Access Compliance Report

Public Rights-of-Way

(Curb Ramps)

Intersection ID: 4324	Main Street: LAKEVIEW_RD	Cross Street: POTOMAC_BV	Location: NE
ADA ID: 3BC0CA16A034	Ramp Type: Directional1	Initial Pass/Fail: Pass	Overall Compliance: No
Severity Score: 0			
Codes/Mitigation Info/Possible Solution		Field Measurements/Component Compliance

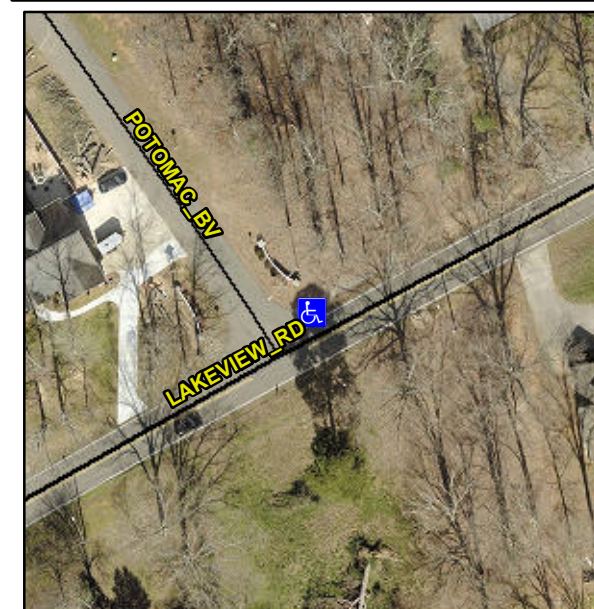
**R304.2.2-Perp, R304.3.2-Para,
R304.5.3, R305.2**

Compliance	Description	Data	Compliance	Description	Data
N/A	Ramp Length (in)	59.5	Yes	Grade Break?	Yes
Yes	Ramp Width (in)	60.0	Yes	Grade Break Slope (%)	2.3
Yes	Ramp Slope (%)	2.7	No	Grade Break XSlope (%)	2.4
Yes	Ramp XSlope (%)	0.5			
N/A	Flare Type LT	N/A	N/A	Flare Type RT	N/A
N/A	Flare Slope LT (%)	N/A	N/A	Flare Slope RT (%)	N/A
N/A	Flare Traversable LT?	N/A	N/A	Flare Traversable RT?	N/A
Yes	Landing Length (in)	60.0	Yes	DWS Provided?	Yes
Yes	Landing Width (in)	60.0	Yes	DWS Contrast?	Yes
No	Landing Slope (%)	3.3	Yes	DWS Length (in)	24.0
Yes	Landing X Slope (%)	0.4	Yes	DWS Full Width?	Yes
N/A	Landing Curb? (Y/N)	No	No	DWS Offset LT (in)	74.0
N/A	Shared Landing?	No	No	DWS Offset RT (in)	4.0
Yes	Gutter Ponding?	No	Yes	Gutter Slope (%)	1.1
Yes	Gutter Lip Ht (in)	0.0	No	Gutter X Slope (%)	3.6
N/A	Painted X Walk1?	No		Road Slope (%)	1.8
	X Walk 1 Direction	To W		Road X Slope (%)	1.8
	X Walk 1 Width (in)	N/A		Clear Space?	Yes

**Remove & Replace Entire Ramp.
Remove & Replace Gutter.**
